LAND USE APPLICATION SUMMARY

Property Location: 1201 & 1203 Bryant Ave N, 1130 7th St N
Project Name: Banaadir Academy Addition
Prepared By: Mei-Ling Smith, Senior Planner, (612) 673-5342
Applicant: 1130 LLC
Project Contact: V. Cletis Levisay II
Request: To construct an addition on an existing school.
Required Applications:

Expansion of a Legal Nonconforming Use	To construct an addition to an existing school located in the II Light Industrial District.
Site Plan Review	For a 14,725 square foot addition to an existing building.

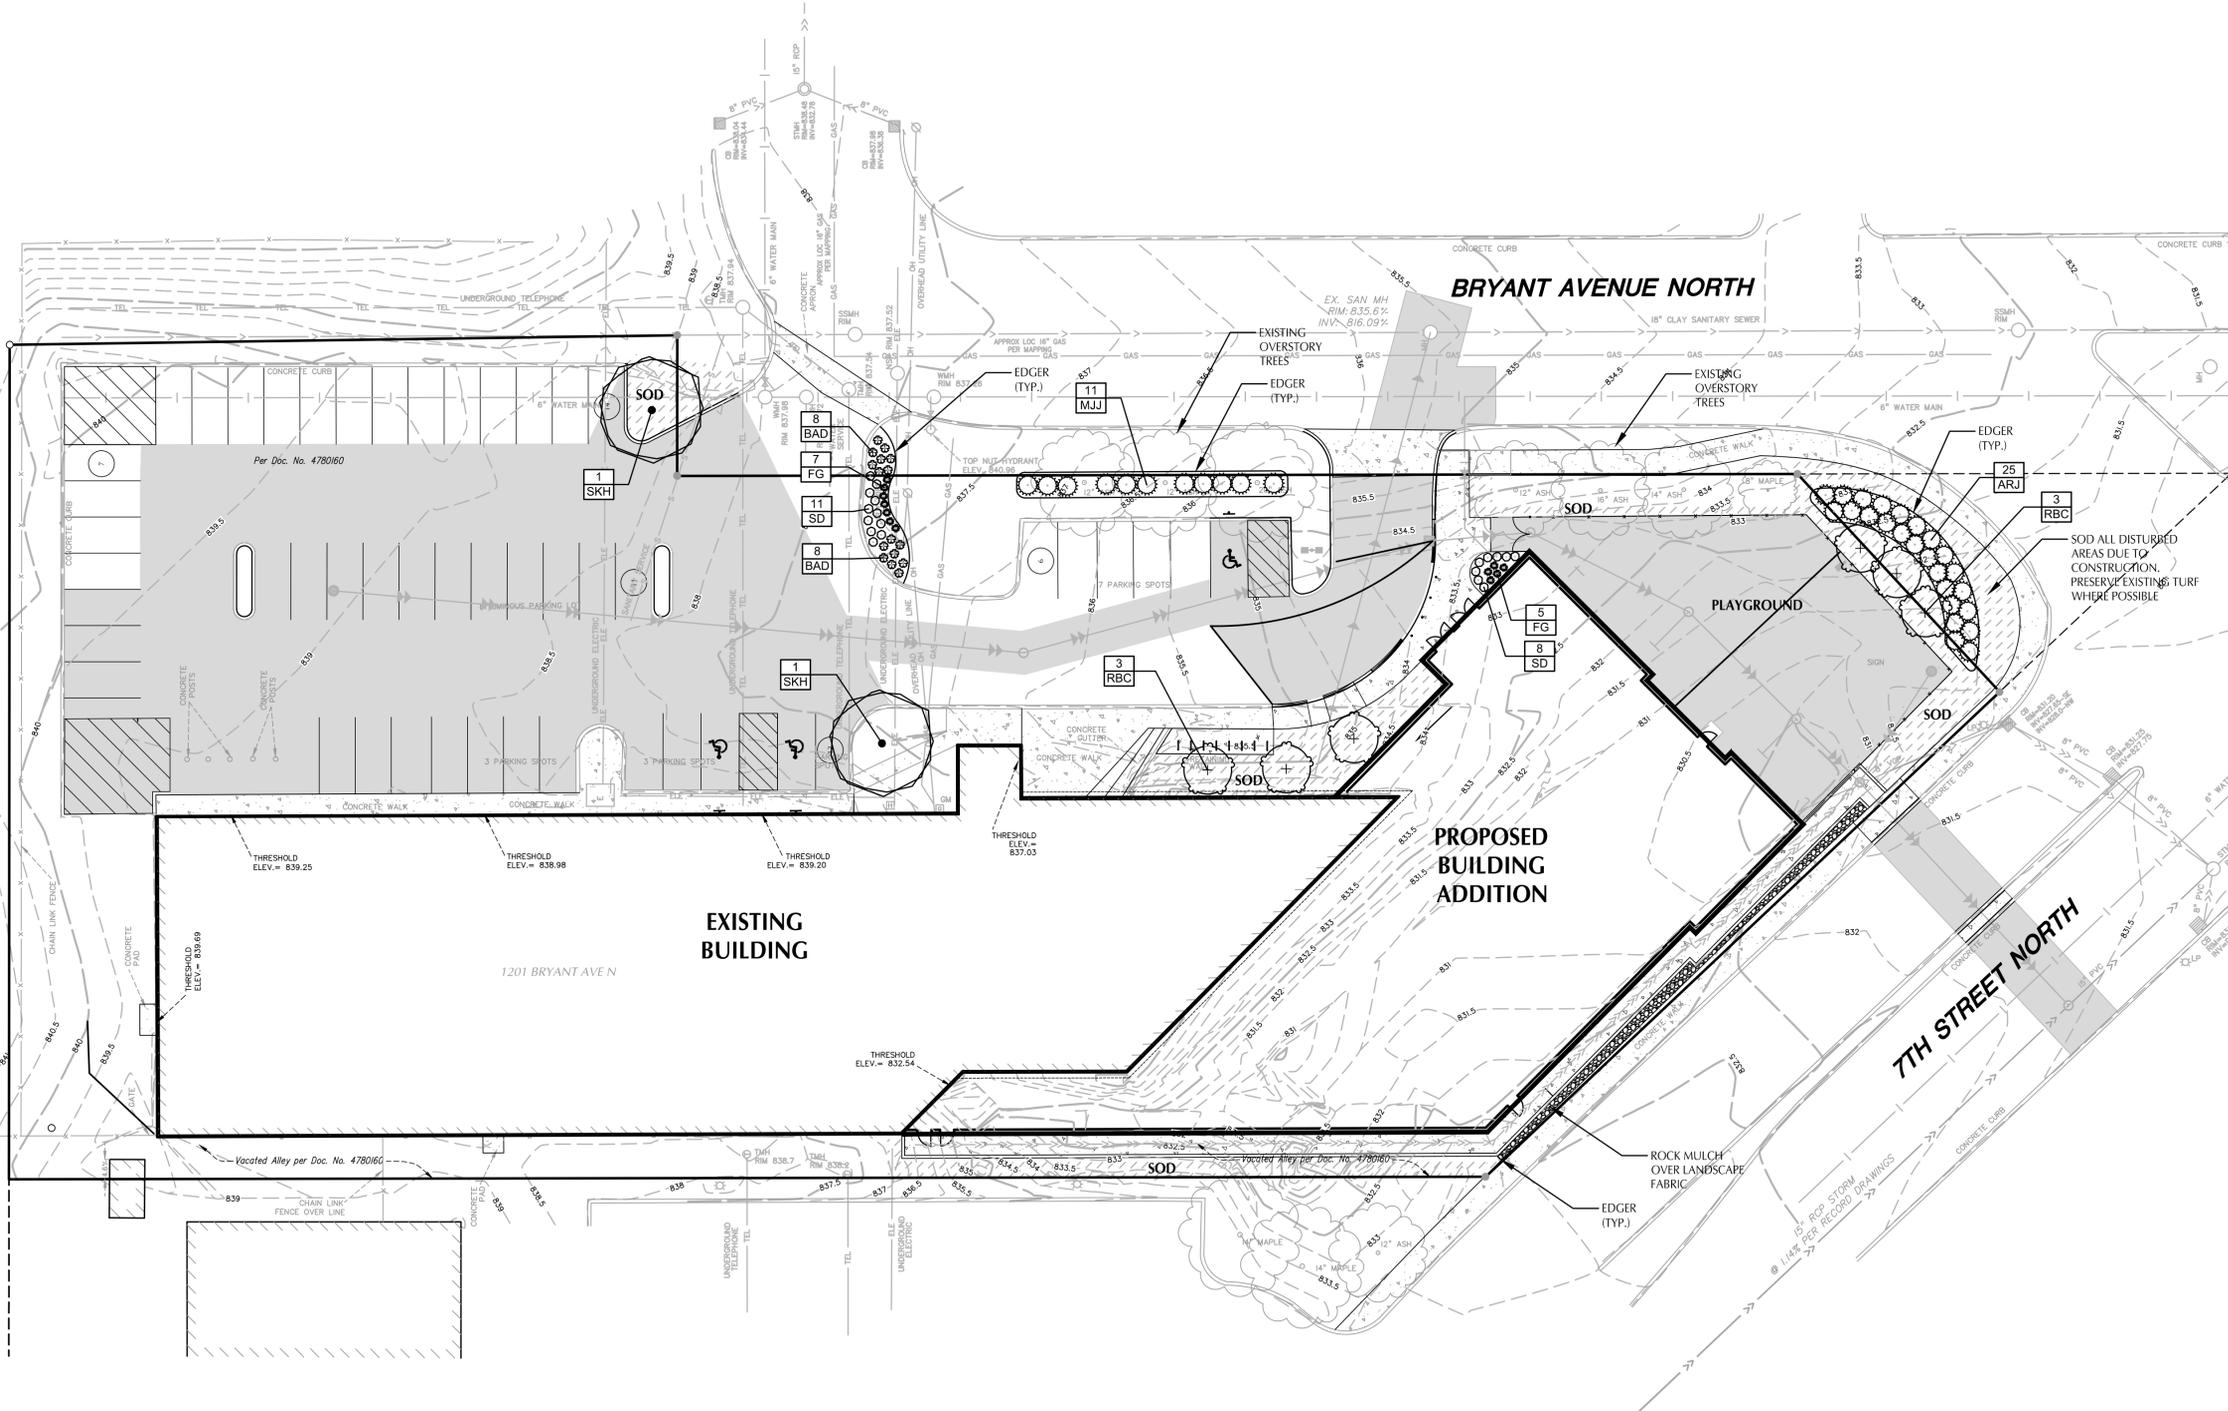
- **Canopy trees.** The applicant is requesting alternative compliance to reduce the minimum canopy tree requirement from 18 to 9. The applicant is proposing to remove three on-site Ash trees from the site to allow for the construction of the addition, retaining wall, and walkway along the south site of the property. As an alternative, the applicant is proposing to plant six ornamental trees on-site and in the adjacent City-owned parcel. Provided that additional trees are planted to meet the screening, interior parking lot landscaping, and 50-foot canopy tree radius requirements, staff recommends granting alternative compliance for this standard.

- **Shrubs.** The shrub requirement for the site is 88 and the applicant is proposing 36 coniferous shrubs, and is therefore requesting alternative compliance. With the recommended conditions of approval, 920 square feet of landscaping would be added to the corners of the parking lot, and at least 10 additional shrubs would need to be planted. There is also approximately 320 square feet of on-site landscaped area between the playground and 7th St N where there are no trees, shrubs, perennials, or grasses proposed. Staff recommends that the applicant provide no fewer than 10 shrubs in this location.

- **Interior landscaping of parking lots.** The landscaping plan submitted by the applicant does not show landscaping as specified for a required landscaped yard in the corners of the parking lot that

8. The corners of parking lots unavailable for parking or vehicle circulation shall be landscaped as specified for a landscaped yard, as required by section 530.170 of the zoning code.
9. All surface parking spaces shall be located within 50 feet from the center of an on-site deciduous tree, as required by section 530.170 of the zoning code.
10. The applicant shall provide no fewer than 20 additional on-site shrubs, of which 10 shall be distributed in the corners of the parking lot and 10 shall be planted between the proposed playground and 7th St N.

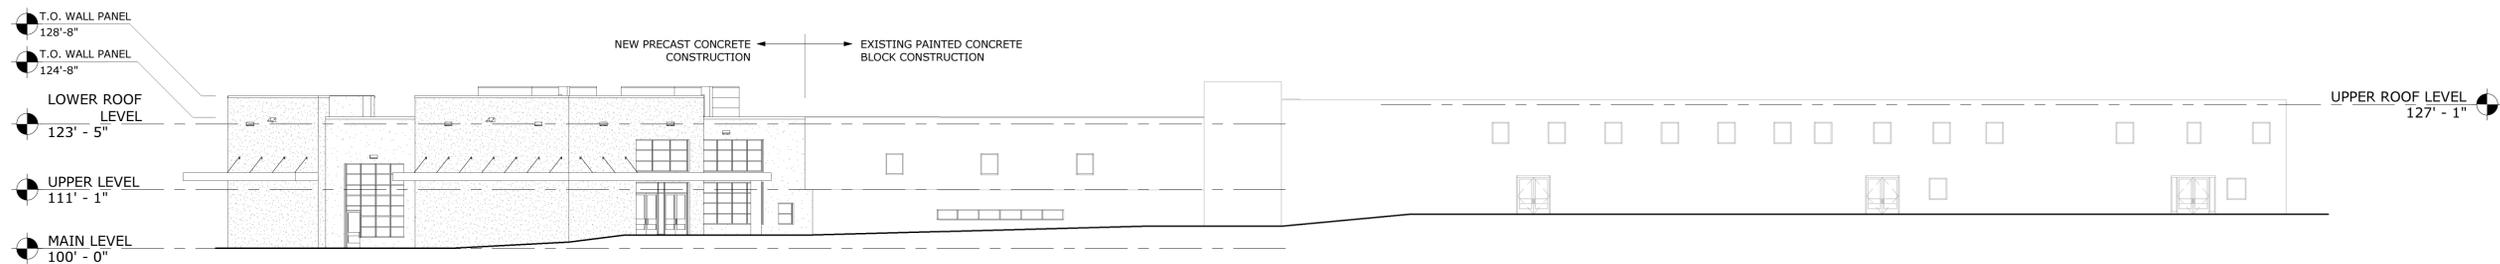
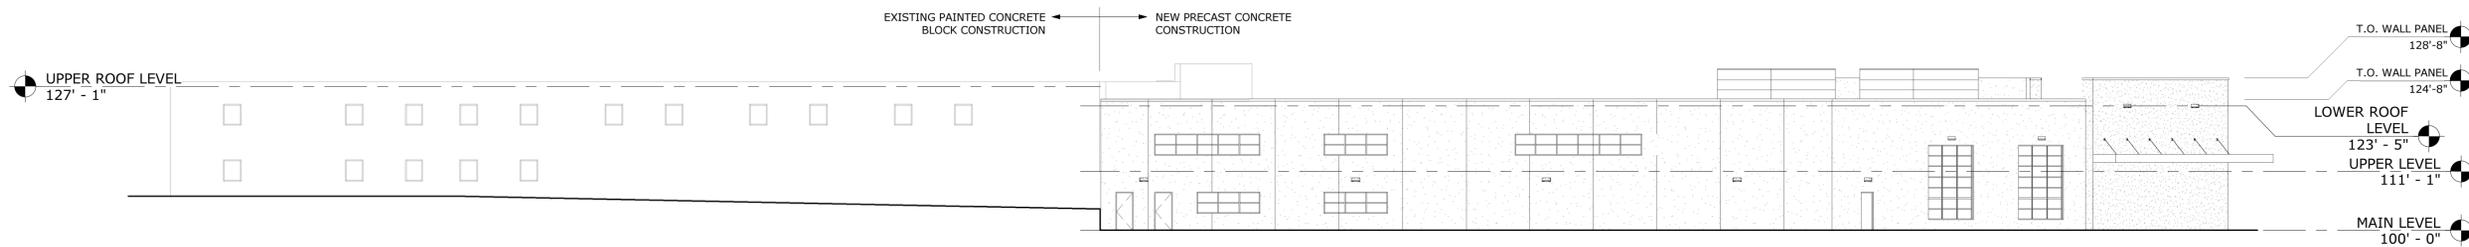
- **Windows.** The project is in compliance with the 10 percent minimum window requirement for the second floor of the west elevation, but is not in compliance with minimum window requirement on all other floors facing the public street on the west, east, and south elevations (see Table 3). Staff recommends that the applicant provide no less than 100 square feet of additional windows on both the west and east elevations to bring the addition into greater compliance with the minimum window requirement.

- **Ground floor active functions.** The ground floor facing the 7th St N does not comply with the 70 percent minimum requirement, as 41 percent (61feet) of the ground floor facing 7th St N contains storage or mechanical rooms, leaving only 59 percent as active functions. The applicant is requesting alternative compliance for the ground floor active functions requirement on the west elevation. Staff finds that it would be reasonable to grant alternative compliance, given that the recommended conditions of approval would require the applicant to add visual interest to the west elevation.

5. The applicant shall eliminate the blank walls exceeding 25 feet on the southernmost portion of the west, south, and east elevations by adding windows, entries, recesses or projections, or other architectural elements.

6. The applicant shall provide no less than 100 square feet of additional windows on both the west and east elevations.
7. A three-foot screen that is at least 60 percent opaque shall be maintained between all parking areas and the public street, as required by section 530.170 of the zoning code.
